FILE P.I. #0004688
MSL00-0004-00(688)
Paulding County
Easr Hiram Parkway
from SR 92 to SR 6/US 278

SUBJECT **APPROVED REVISED CONCEPT REPORT**

REVISED CONCEPT REPORT

Project Number: MSL-0004-00(688) Paulding County
County: Paulding
P.I. Number: 0004688
Federal Route Number: None
State Route Number: Temporary SR 1200

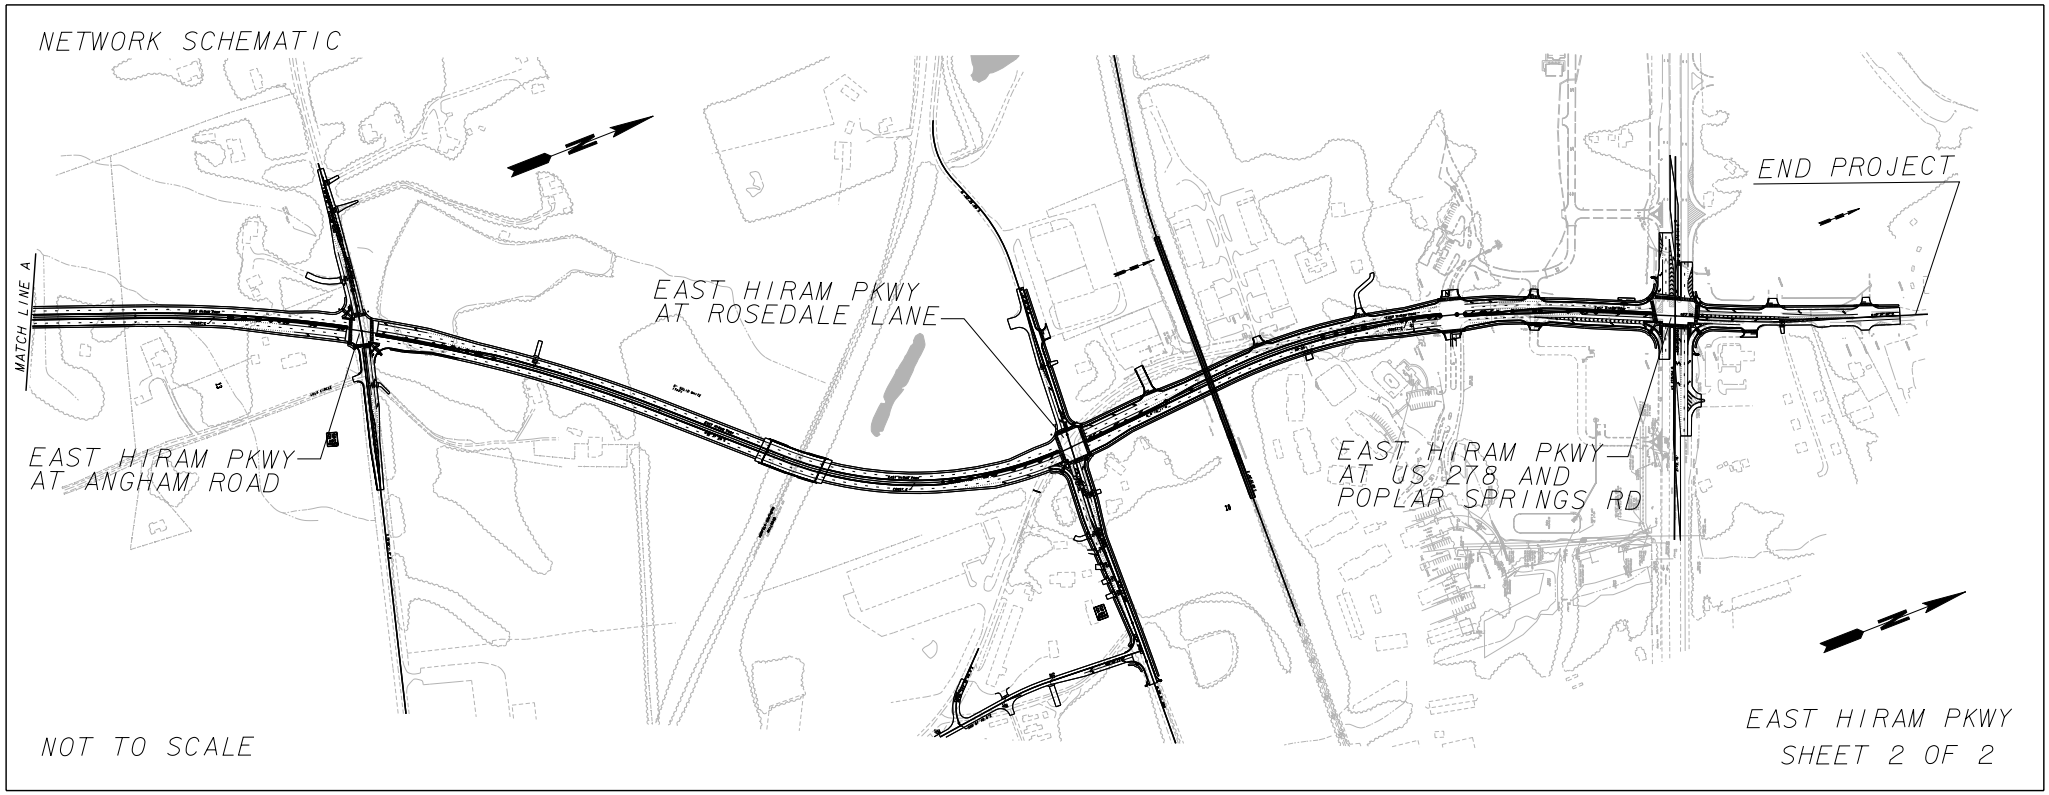
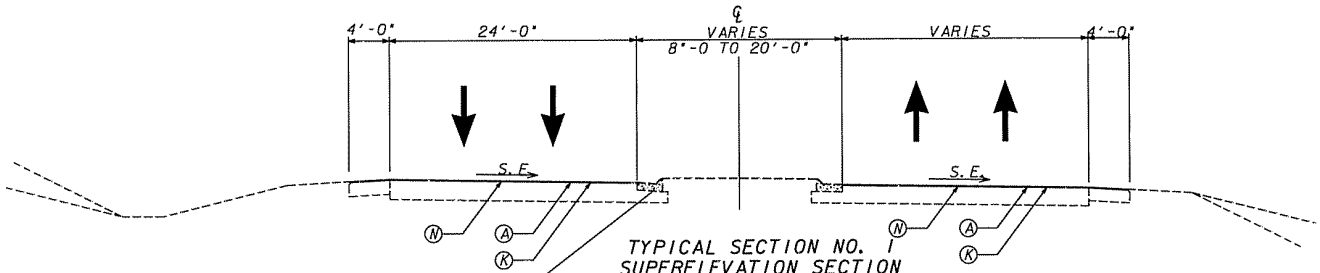
(1) The Total Length of Project has changed from 2.70 miles to 2.90 miles.
The original project length did not include improvements to the West Hiram Parkway at the southern project terminus and Poplar Springs Road at the northern project terminus.

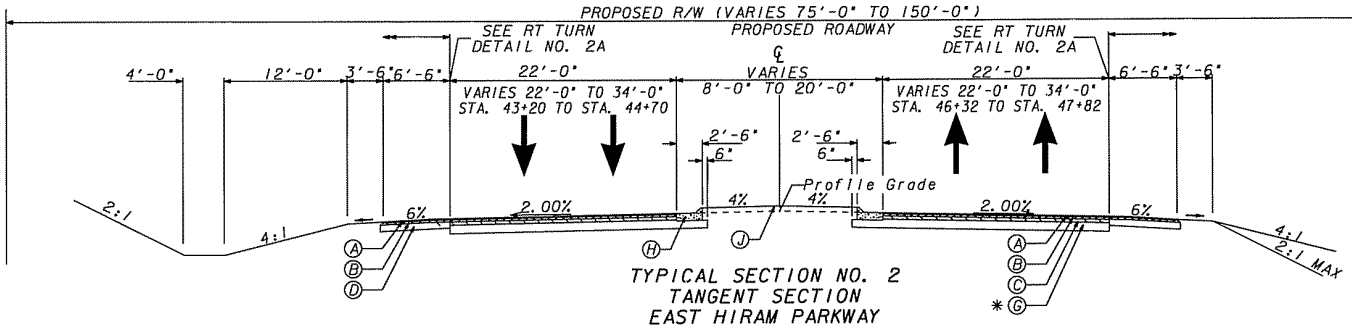
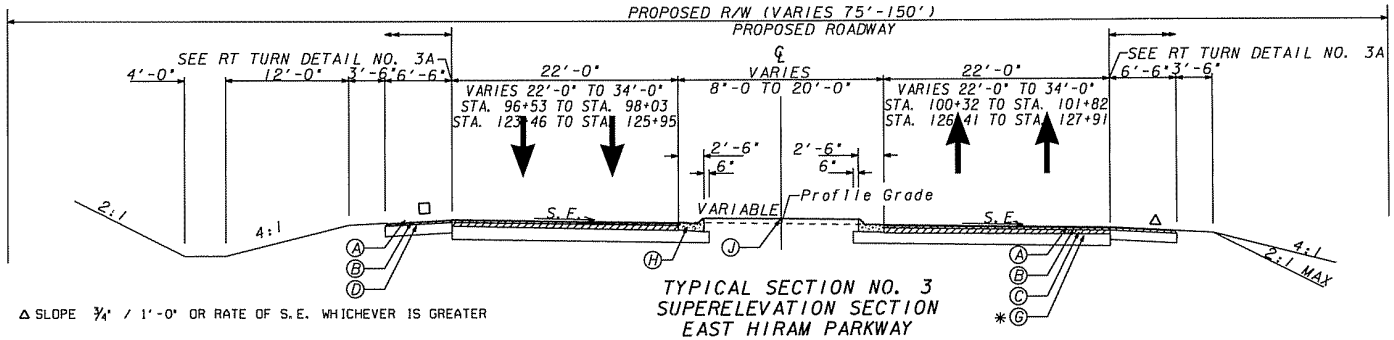
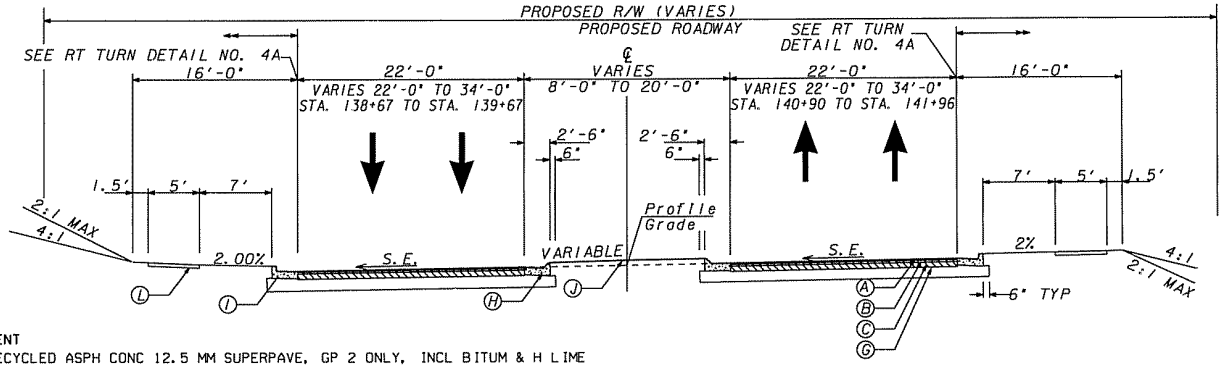
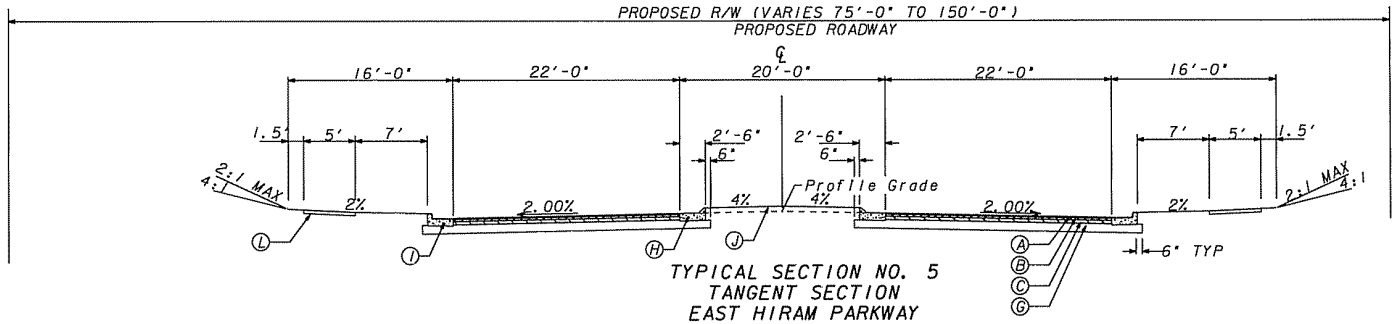
(2) Travel Lane widths were reduced from 12 feet to 11 feet in width. Lanes were reduced from 12 feet to 11 feet due to the results and recommendations from the Value Engineering Study.

Proposed Features (Continued): The construction proposes four, 11' lanes with 10' rural shoulders and an 20' raised median from SR 92 to Rosedale Lane and four, 11' lanes with 16' urban (curb and gutter) shoulders and an 20' raised median from Rosedale Lane to US 278/SR 6. The construction also proposes a median reduction from 20' to 12' beginning at SR 92 and extending east approximately 2,800 feet and will require a design variance.
Reason For Change: The Total Length of Project has changed from 2.70 miles to 2.90 miles. The original project length did not accommodate improvements to the West Hiram Parkway at the southern project terminus or to Poplar Springs Road at the northern project terminus. Changes for the lane width reduction were due to the results and recommendations from the Value Engineering Study.
